Technical Evaluation Report on the Content of the U.S. Department of Energy's Yucca Mountain Repository License Application

**Postclosure Volume: Repository
Safety After Permanent Closure**

Technical Evaluation Report on the Content of the U.S. Department of Energy's Yucca Mountain Repository License Application

Figure 6-1. Potential Flow Pathways in the Engineered Barrier System (SAR Figure 2.3.7-8; DOE, 2008ab)

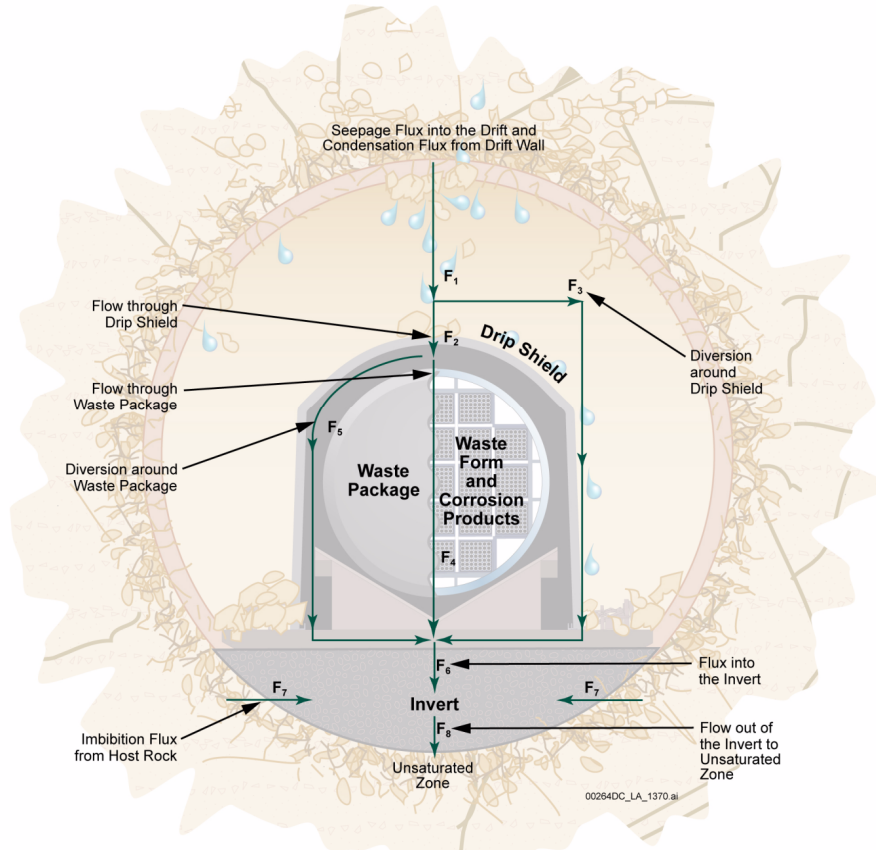
DOE described the flow pathways and flux rates (F1–F8) in the engineered barrier system flow abstraction as follows (Figure 6-1): the F1 flow path accounts for the total dripping flux from a drift wall. The total dripping flux is the sum of the seepage flux arriving at the drift wall from above and the condensed water on drift walls (TER Section 2.2.1.3.6.3.4); these are direct

inputs to the engineered barrier system flow abstraction. The F2 flow path accounts for the flux through partially failed patches of the drip shield formed by general corrosion.
